3. 58 Boyd Street

4. 583-605 Stevens Avenue

7. 383 Commercial Street

**LEGAL ADVERTISEMENT
PORTLAND PLANNING BOARD
MEETING AGENDA**

Sheet No: C-4.0

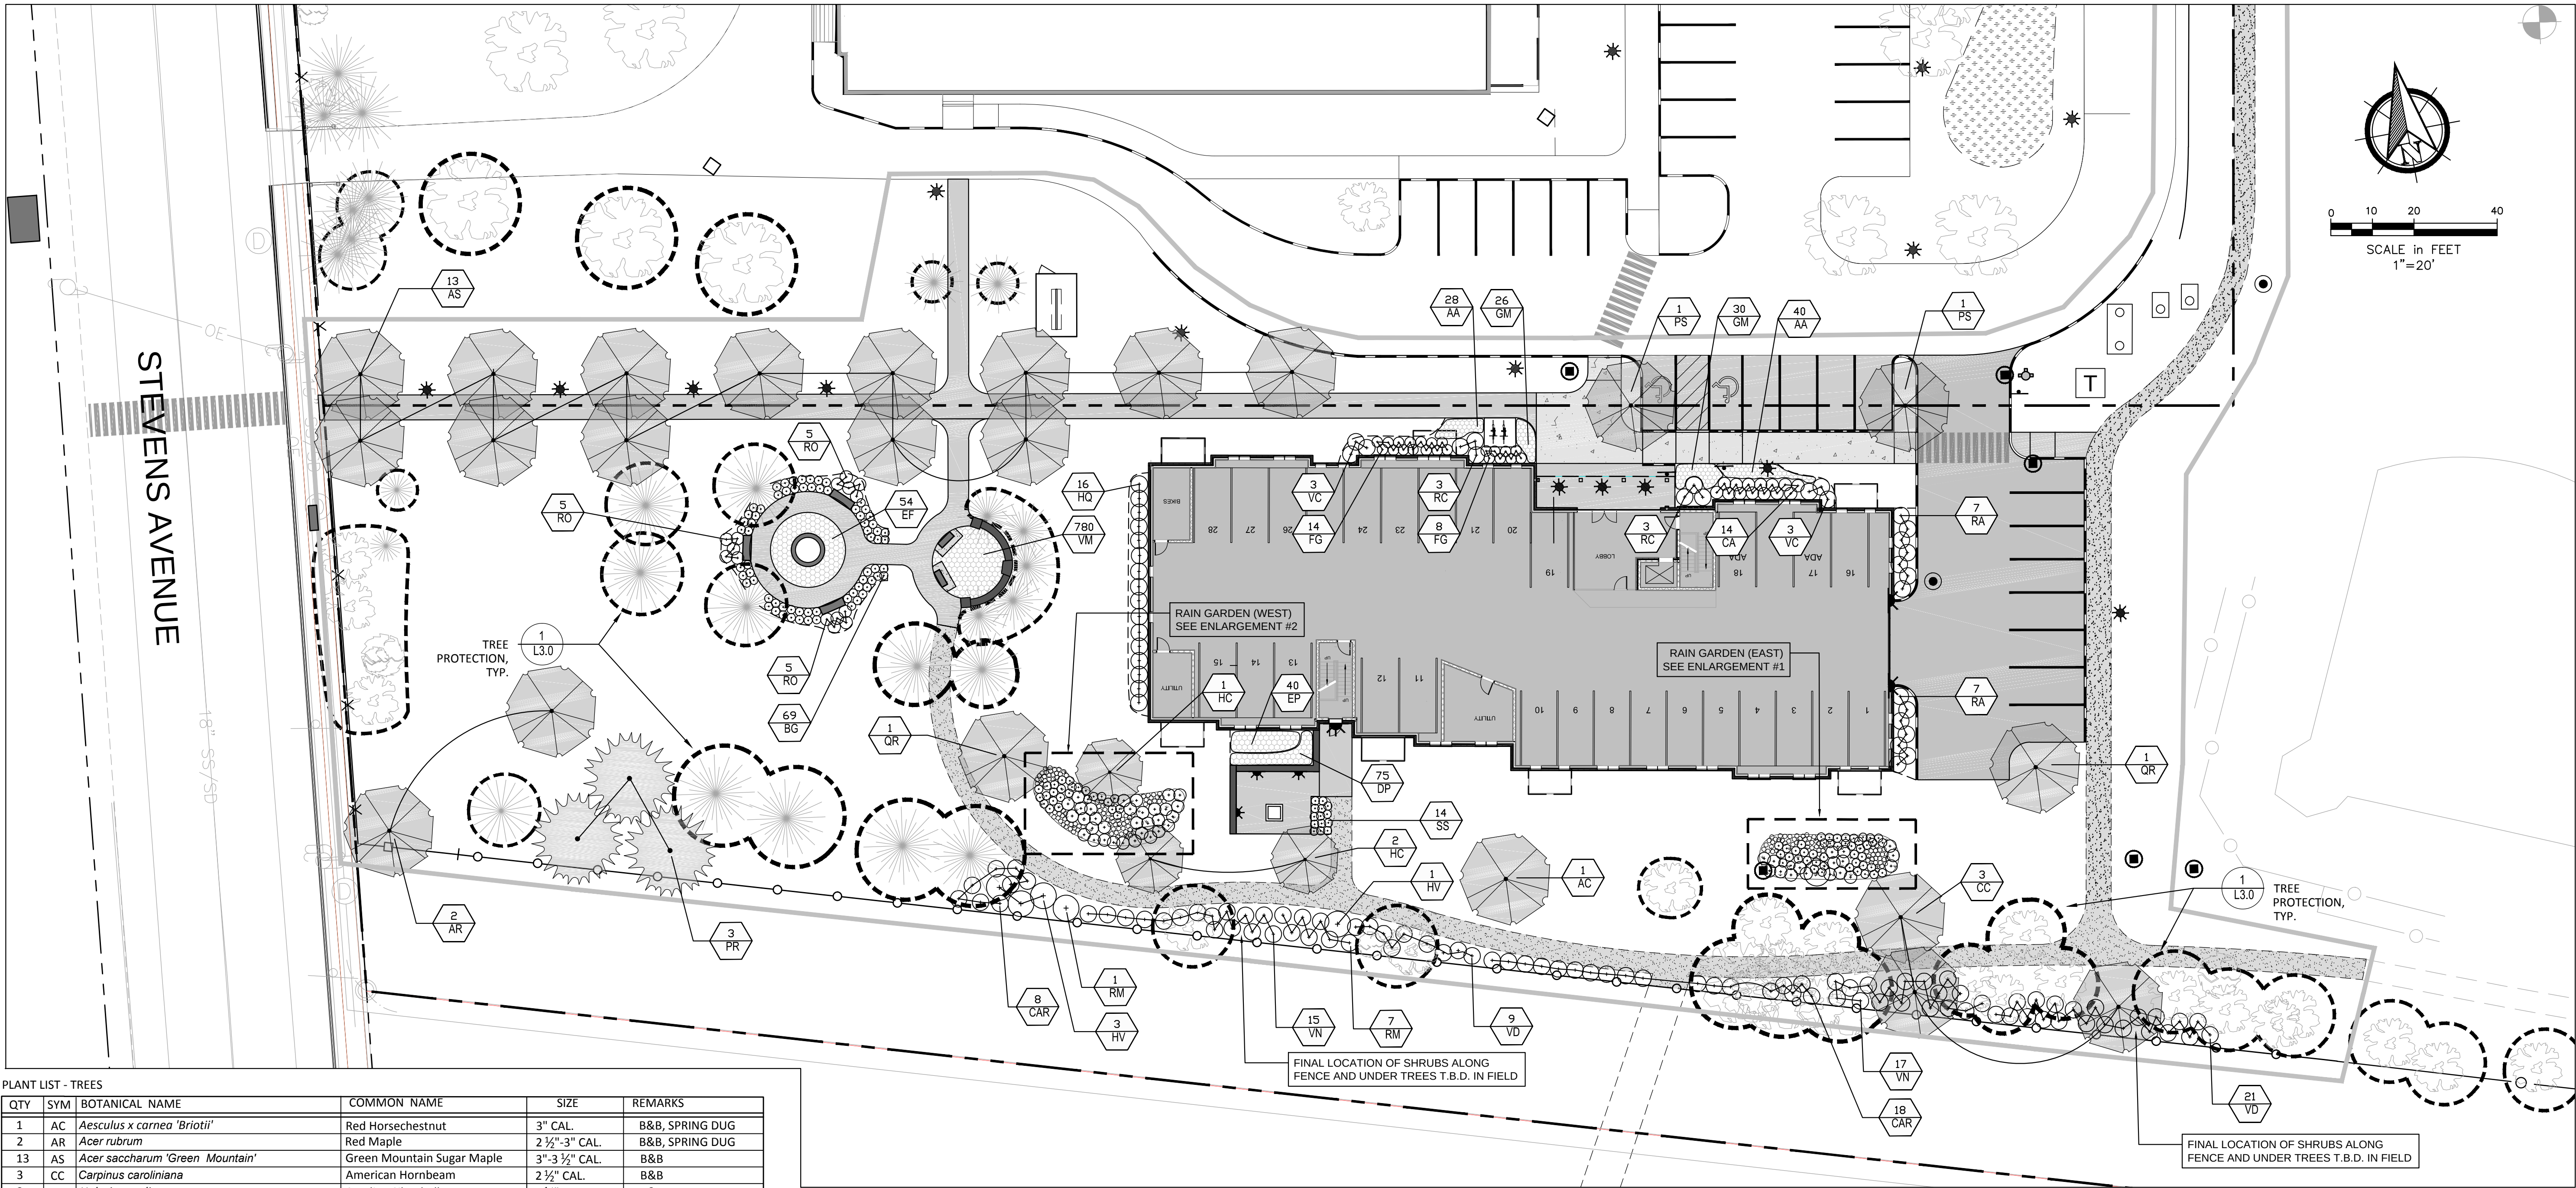
- Sheet C-4 Site Plan. The applicant's site plan shows "by others" for a bench to be placed within the sidewalk in lieu of a required bus shelter. In Exhibit 15, the applicant suggests that its current transit facility requirement is being met by the placement and purchase of a shelter by a City-METRO project along the Evergreen Cemetery frontage. The contribution of \$15,800 as part of the Motherhouse MDP and site plan review was for pedestrian accessibility, curb ramp, sidewalk and crosswalk construction. Contrary to what the applicant states in Exhibit 15, city staff feels the applicant still has a current requirement to meet bus stop/shelter-related amenity requirements along/within its frontage to serve its residents and the general public as part of the project undergoing current review.

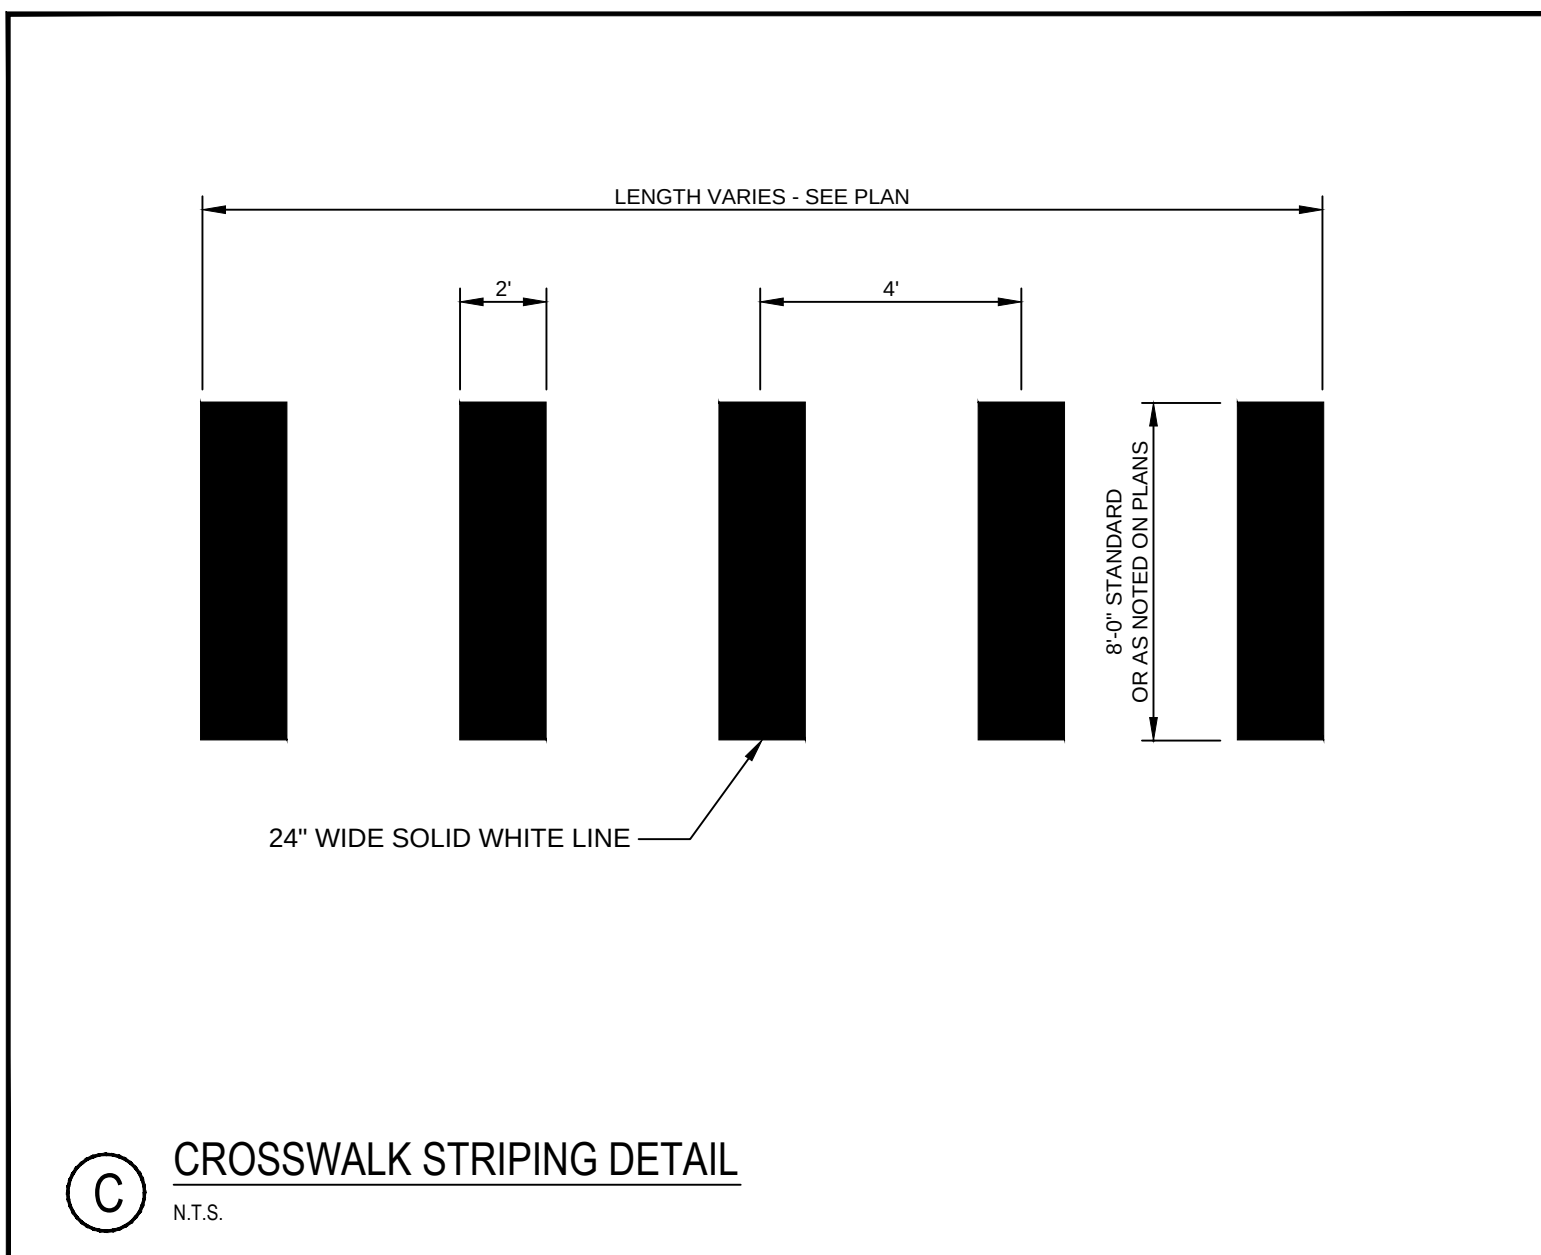
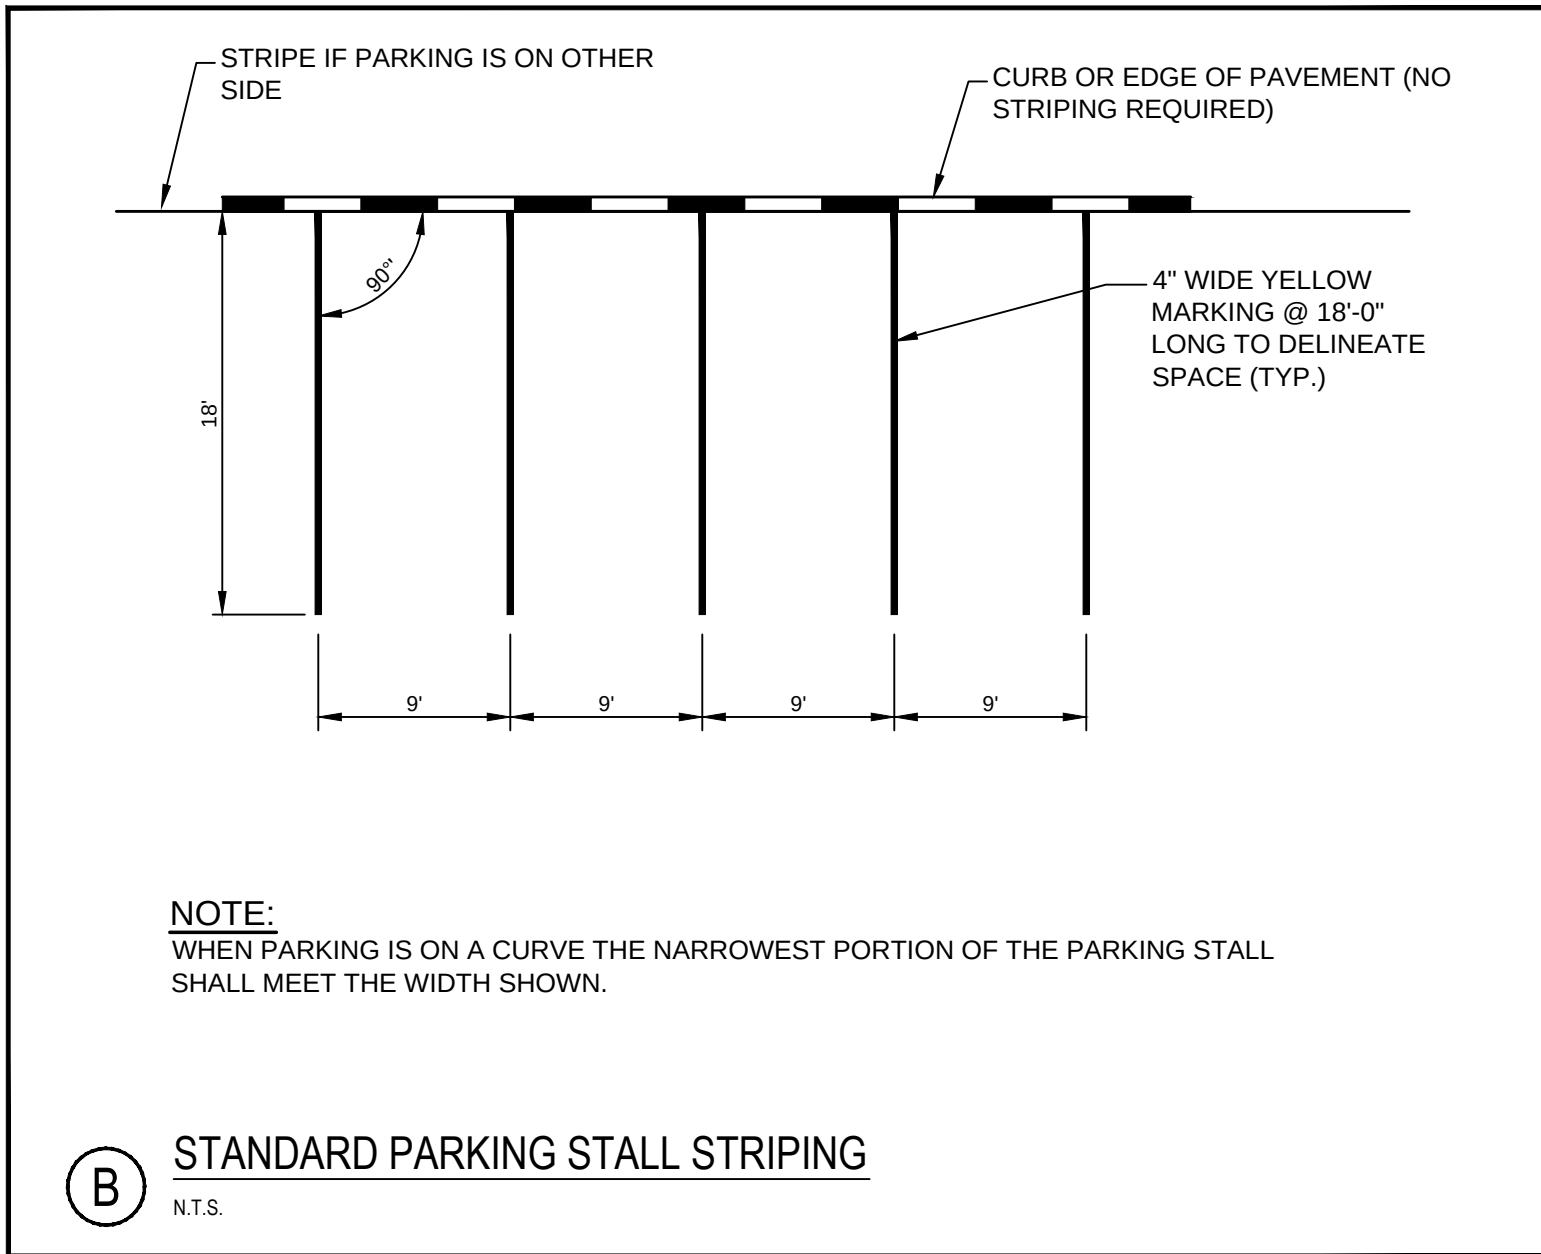
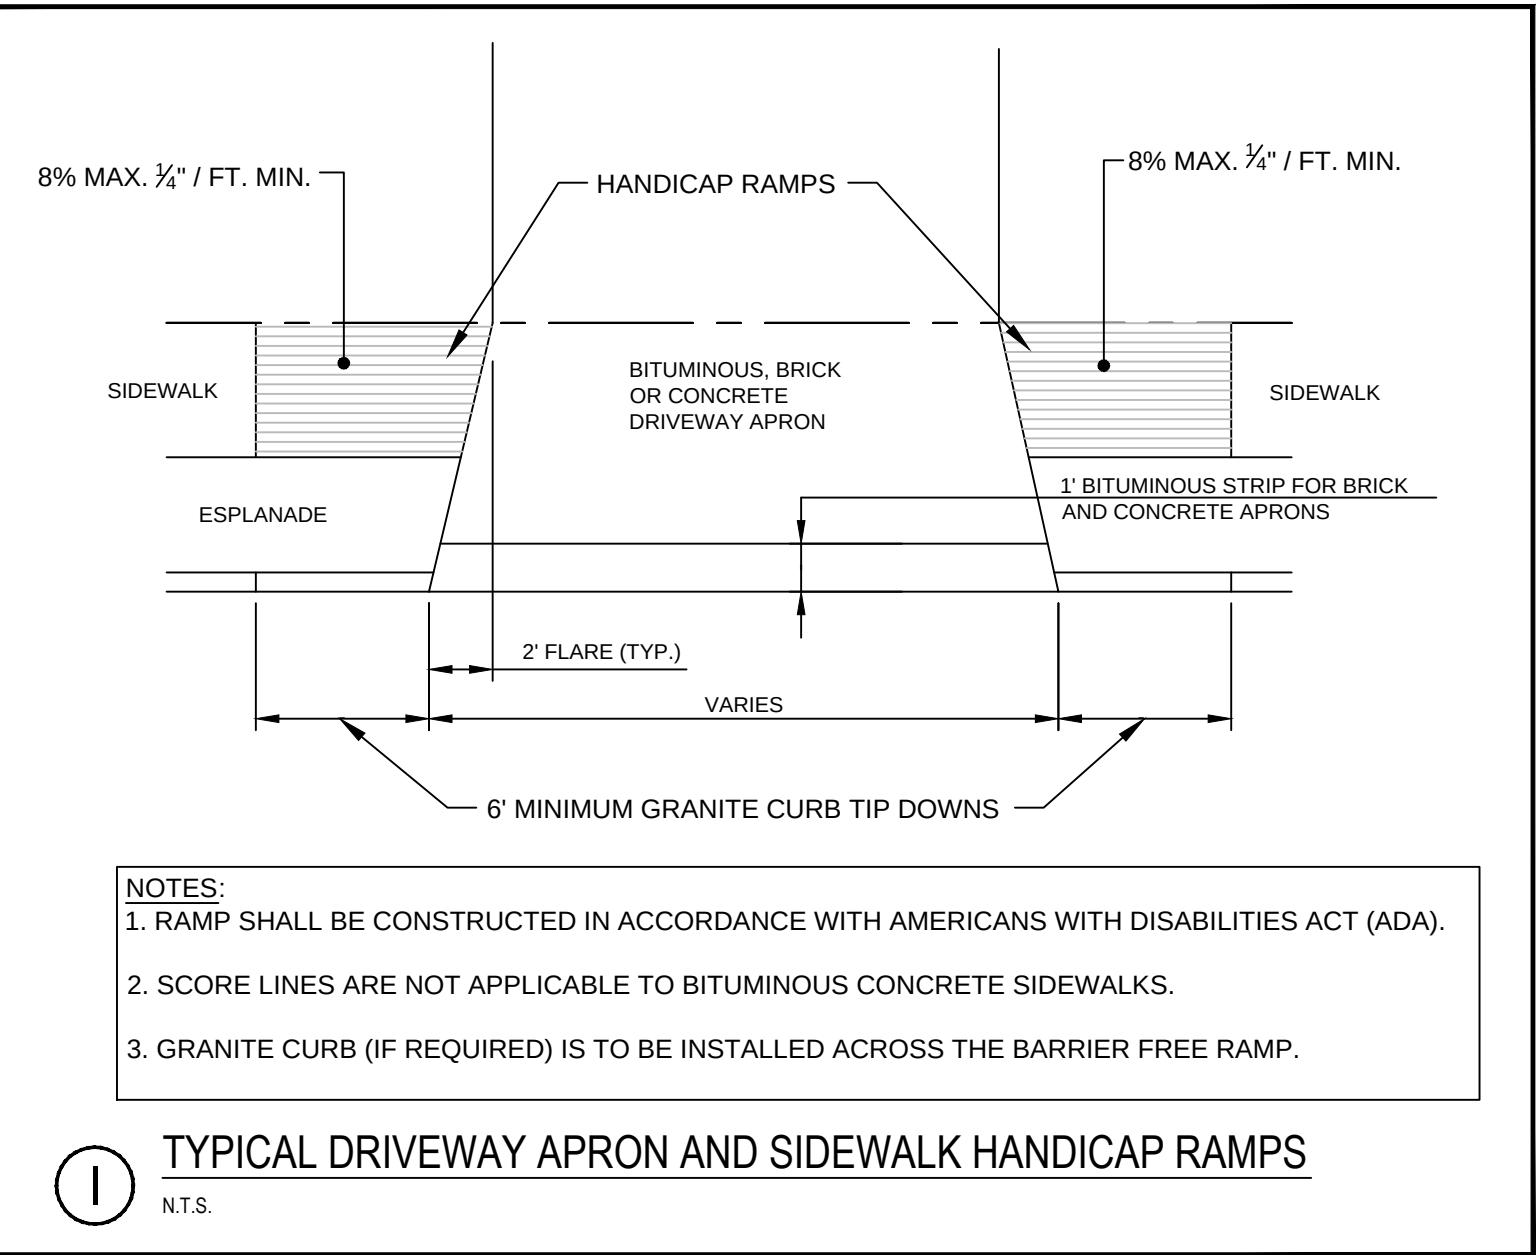
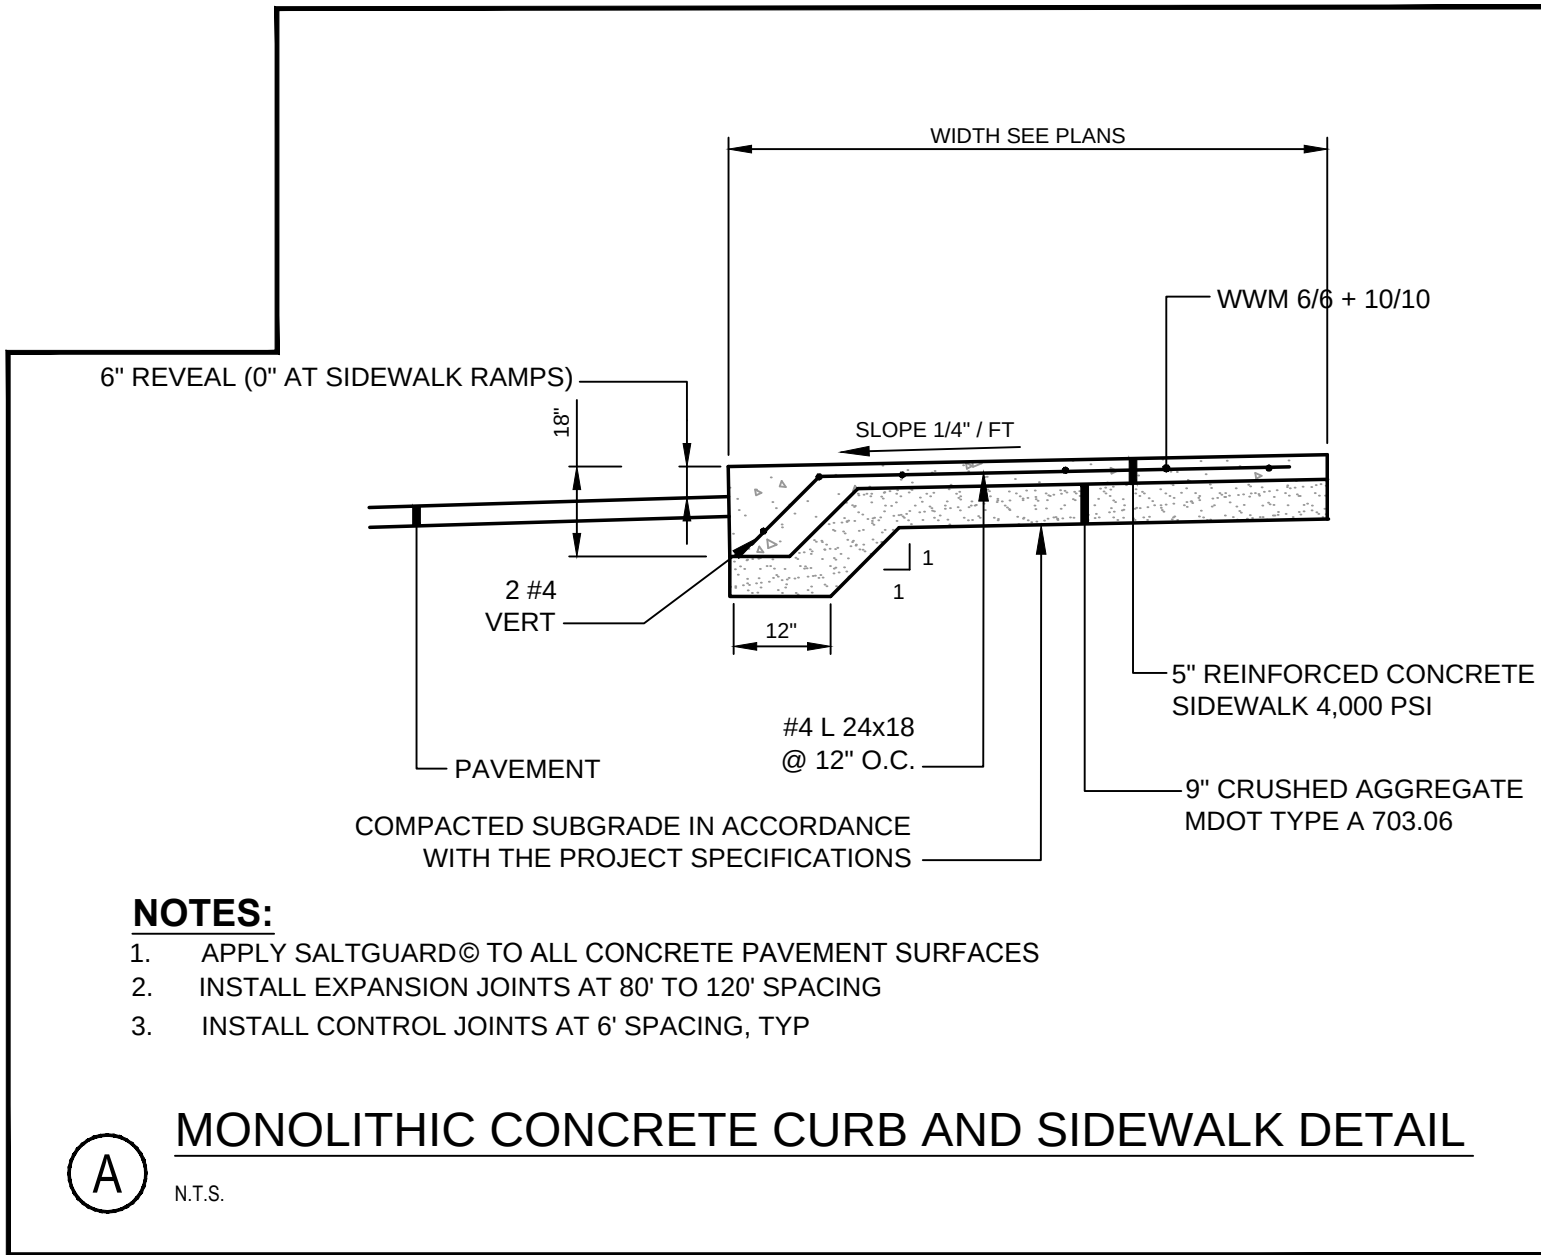
- Sheet C-7.1 Site Details. The sidewalk (A and I-14) and driveway (I and I-15) details shall be revised to show a maximum 2% cross-slope for the ADA-compliant pedestrian access route for sidewalks and across driveways connecting to sidewalks/pedestrian ways. Across driveways, this pedestrian access route should be a minimum 5' where feasible. (The typical city details are being concurrently updated to more explicitly reflect these ADA requirements/maximum cross-slopes.)
